Subject: Duke Energy Carolinas, LLC
William States Lee III Nuclear Station - Docket Nos. 52-018 and 52-019
AP1000 Combined License Application for the William States Lee III Nuclear
Station Units 1 and 2
Supplemental Response to Request for Additional Information (RAI) Letter 110,
Related to SRP Section 02.03.05 – Long Term Atmospheric Dispersion
Estimates for Routine Releases (RAI 7186)
Ltr#: WLG2013.09-01

Response to Request for Additional Information 7186
Question 02.03.05-6(b)
Supplemental Information Related to the Safety Review

Reference NRC RAI Number(s): 02.03.05-6 (eRAI 7186)

Figure 1 - Unit 1 Distance to the Site Boundary

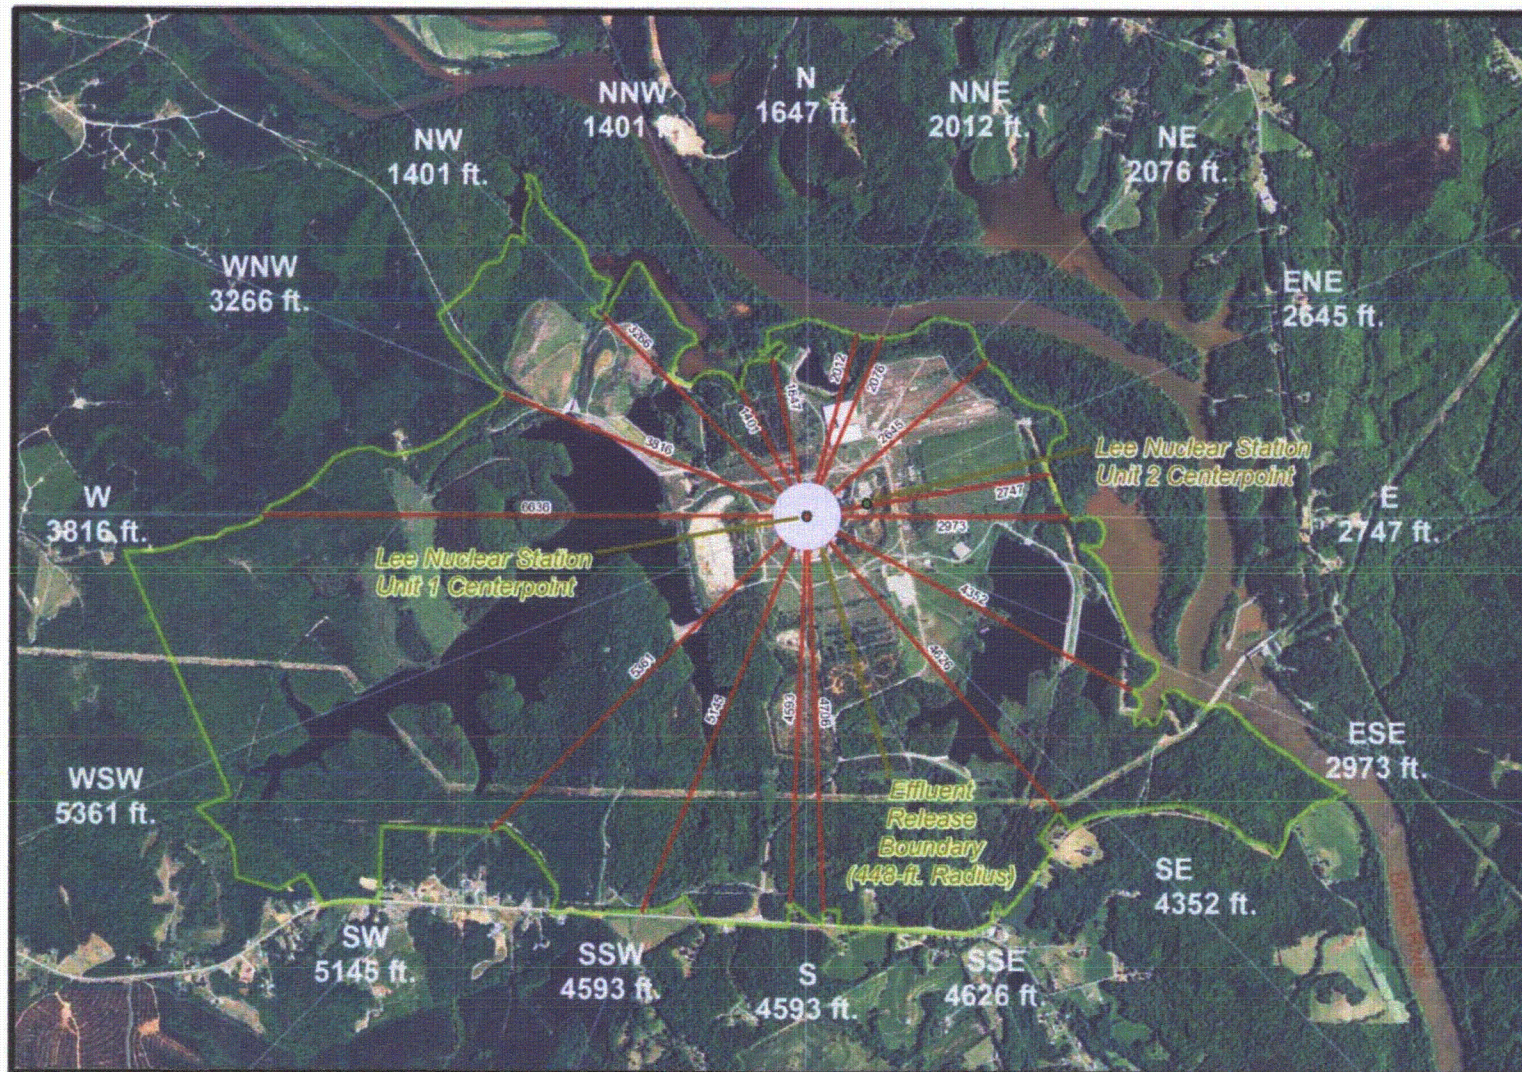
- (b) Determine the appropriate annual average relative concentration (X/Q) and relative deposition (D/Q) values and applicable dose rates at the site boundary for those direction sectors where the site boundary and EAB are not co-located as illustrated in COL FSAR Figures 2.1-209A and 2.1-209B, including, but not limited to:

- Identifying and justifying the appropriate downwind distances by affected sector;
 - Reanalyzing any XOQDOQ routine release dispersion modeling and related dose calculation analyses;

The limiting atmospheric dispersion factor is 1.5×10^{-5} sec/m³ located 1401 feet (approximately 0.27 mi., or 427 meters) NW of the Unit 1 effluent release boundary. The directional sectors and distances from the Units 1 and 2 effluent release boundaries are shown in Attachment 1, Figures 1 and 2. The associated revisions to FSAR Sections 2.0 and 2.3 are presented in Attachments 5, 6, and 7.

Revision to FSAR Figure 1.1-202

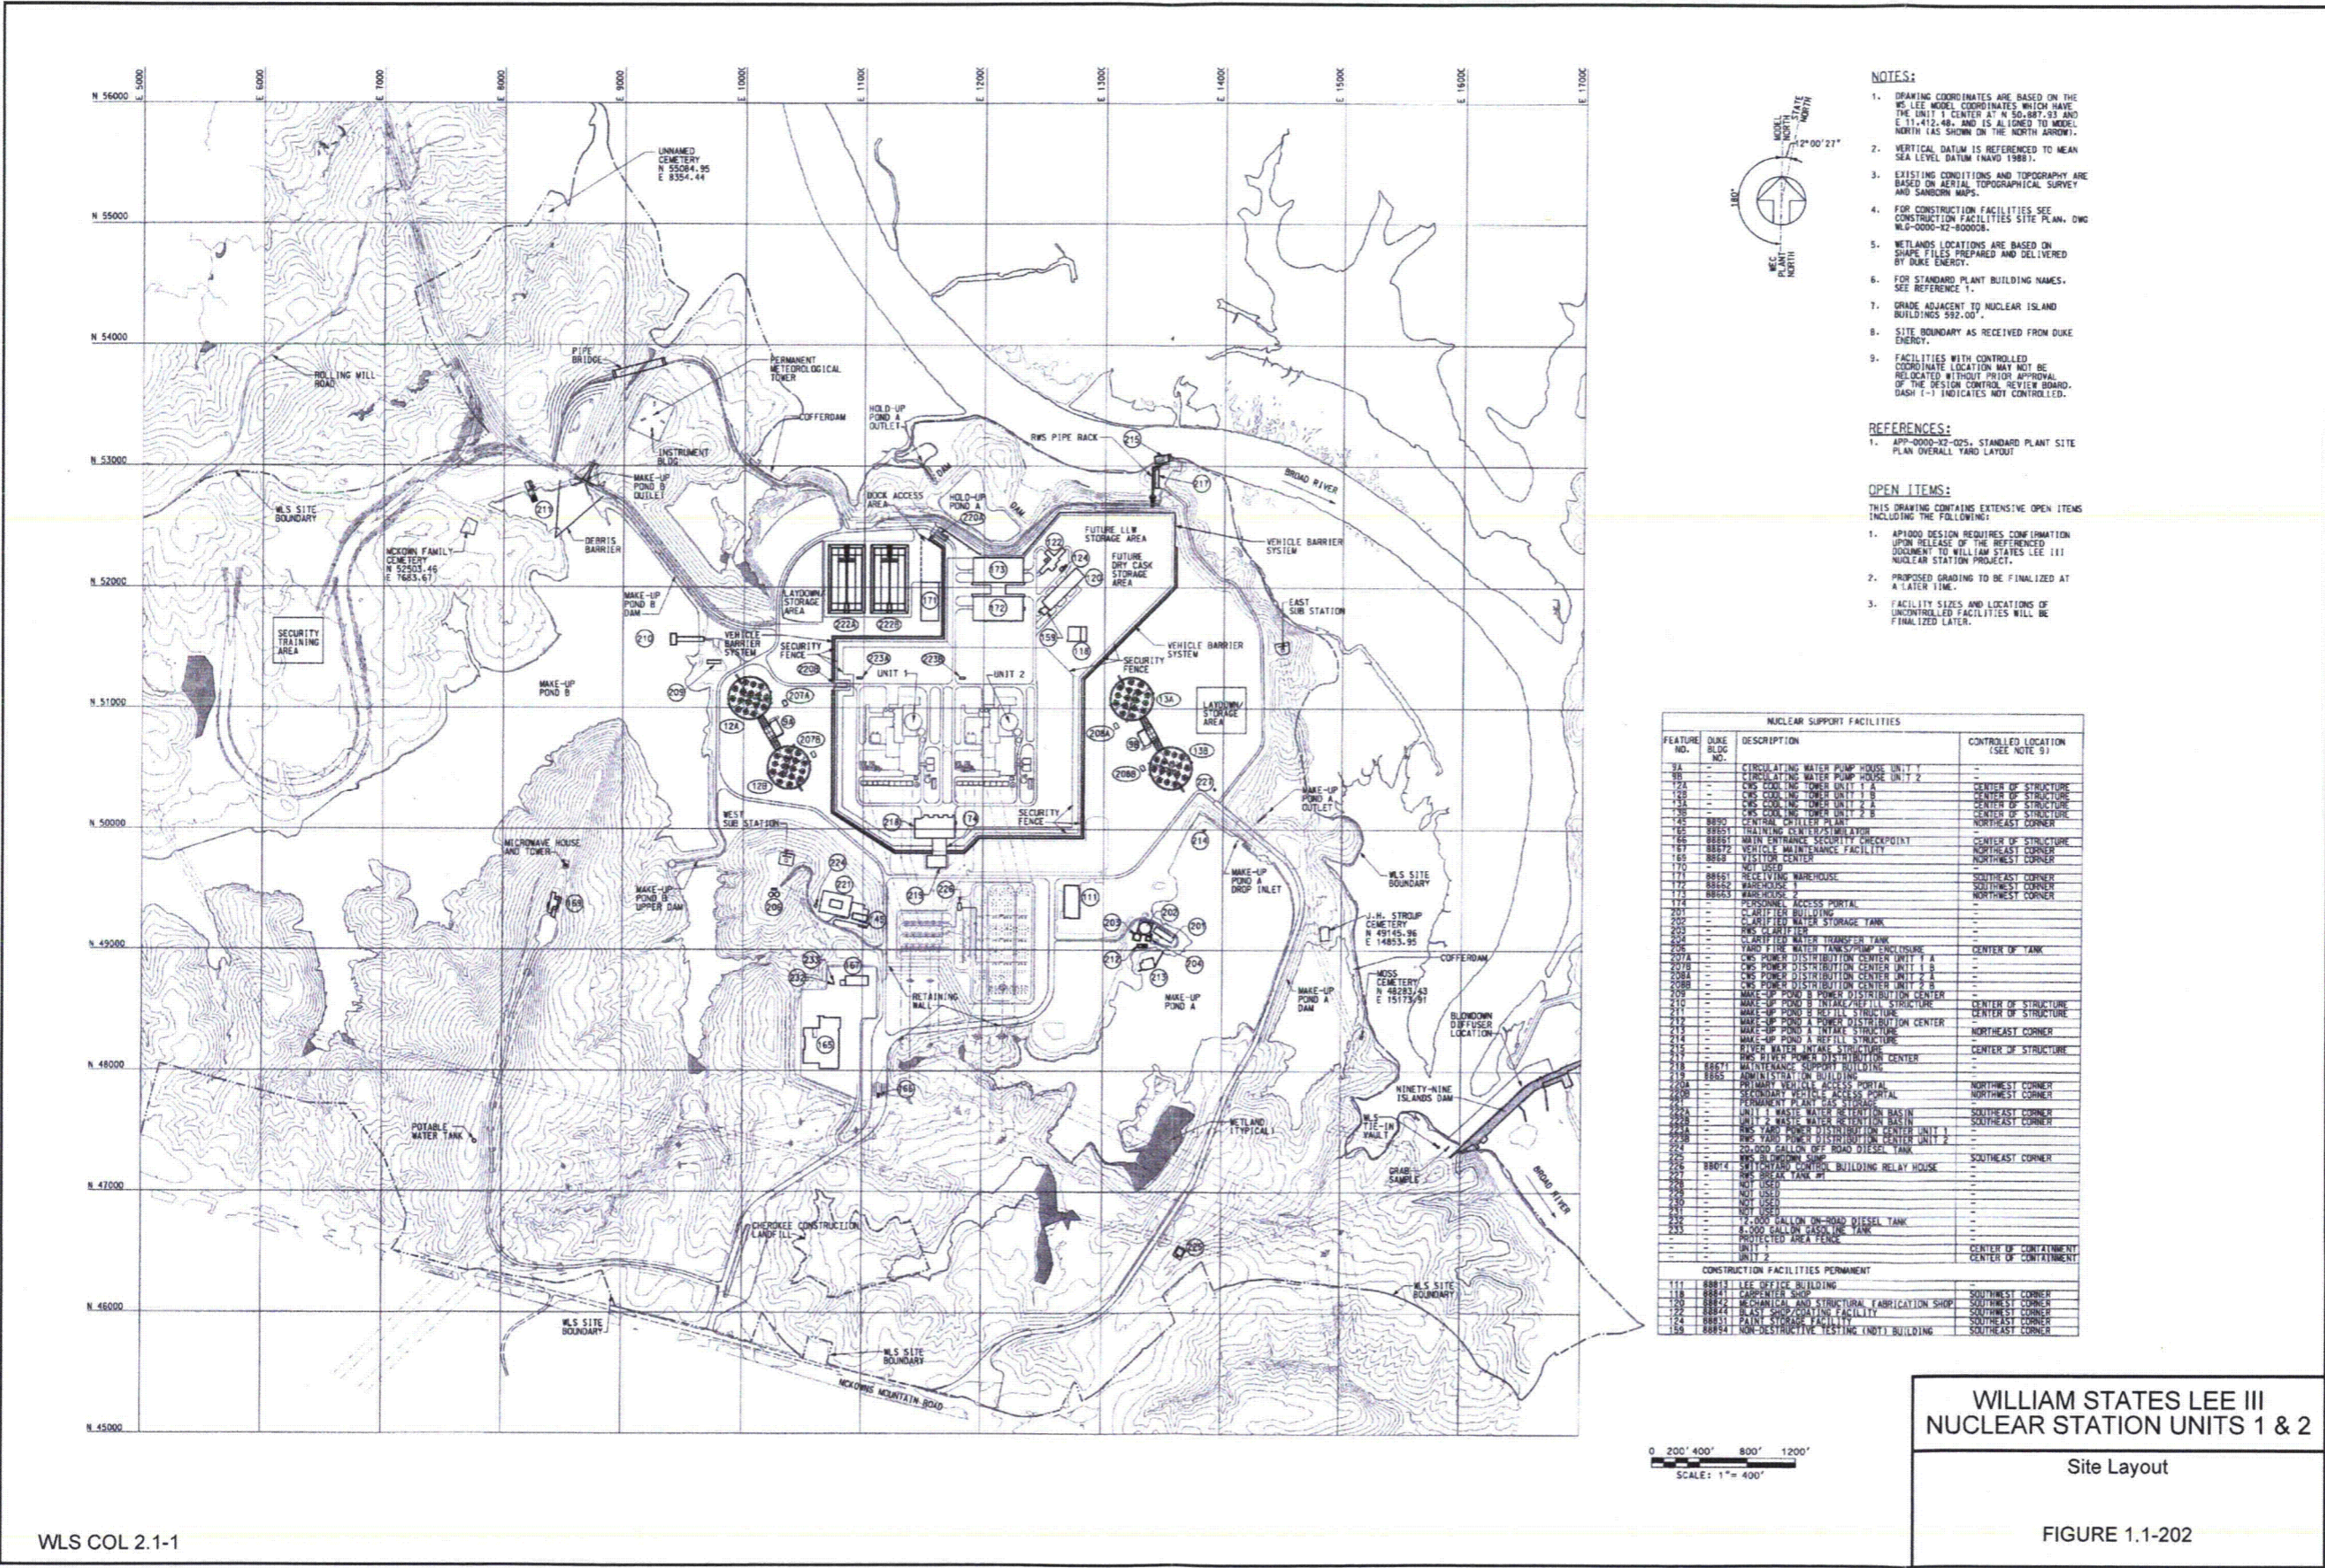
During Duke Energy's analysis, a discrepancy was found on the site boundary presented in FSAR Figure 1.1-202, "Site Layout." The associated revisions to Figure 1.1-202 are presented in Attachment 4.

1. COLA Part 2, FSAR Figure 1.1-202 is revised as follows:

FIGURE 4.1-1 Low Population Zone and Site Boundary Map

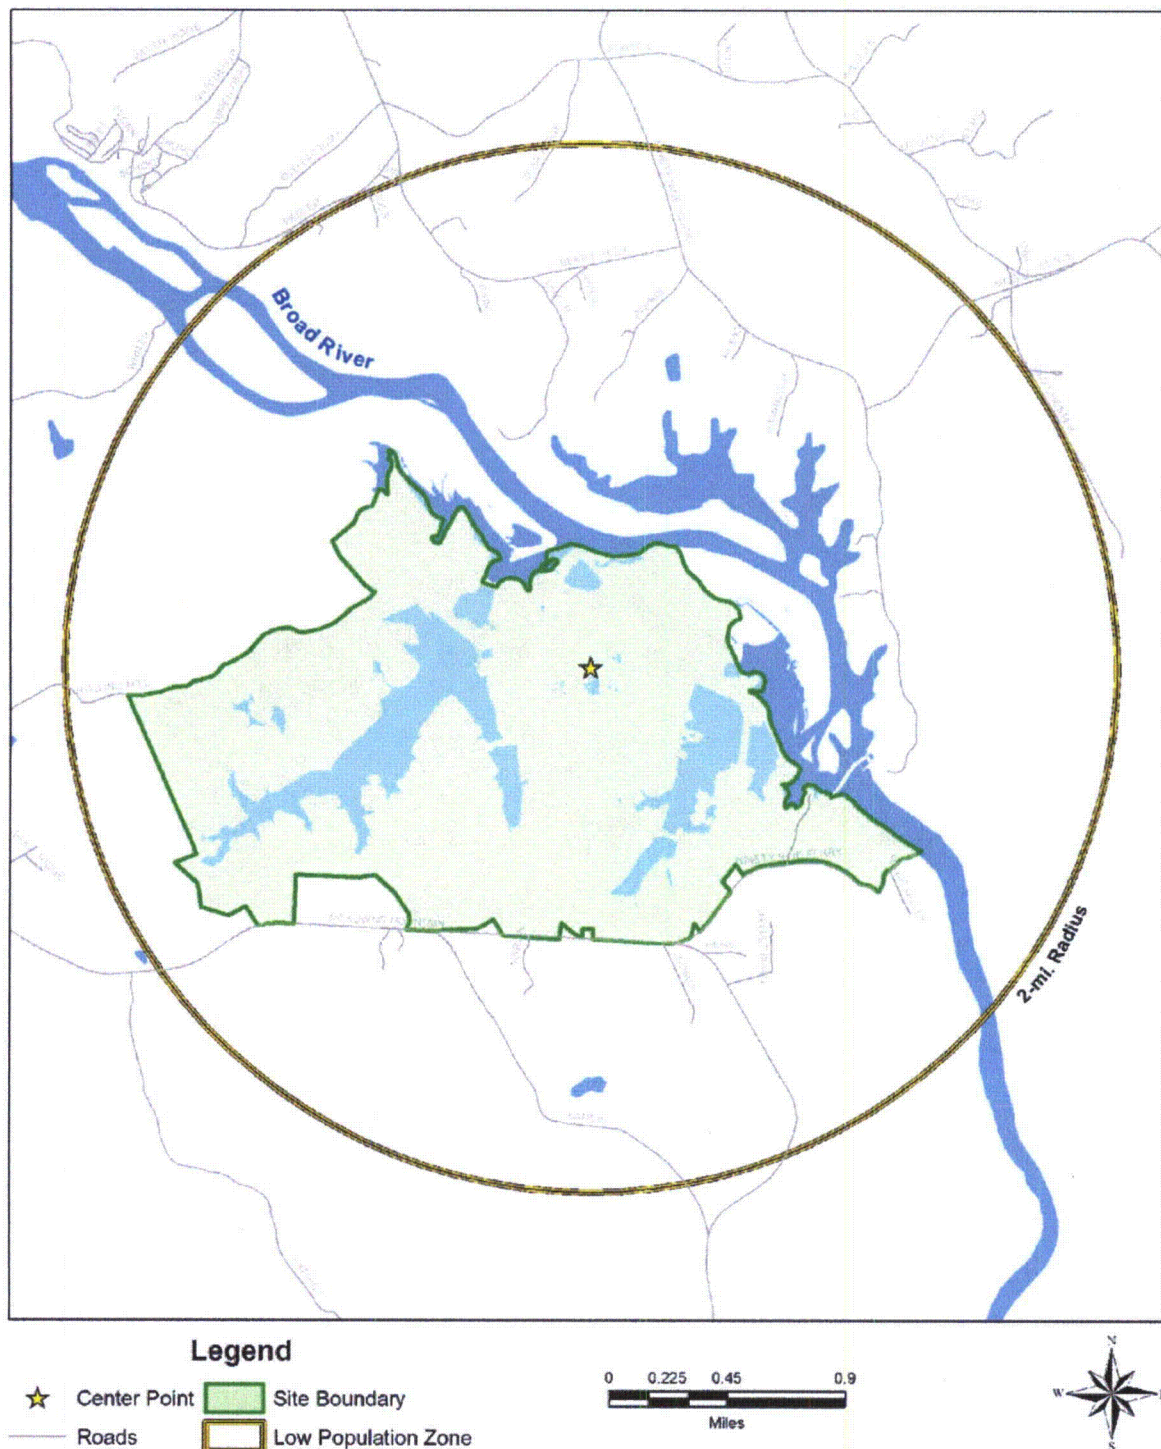
Conforming changes to Part 4, Technical Specifications, Figures 4.1-1 and 4.1-2 are provided in Attachment 10. These changes provide consistency between the site boundary and exclusion area boundary presented in Part 2 and Part 4 of the WLS license application.

1) COLA Part 4, Figure 4.1-1 is revised as follows:
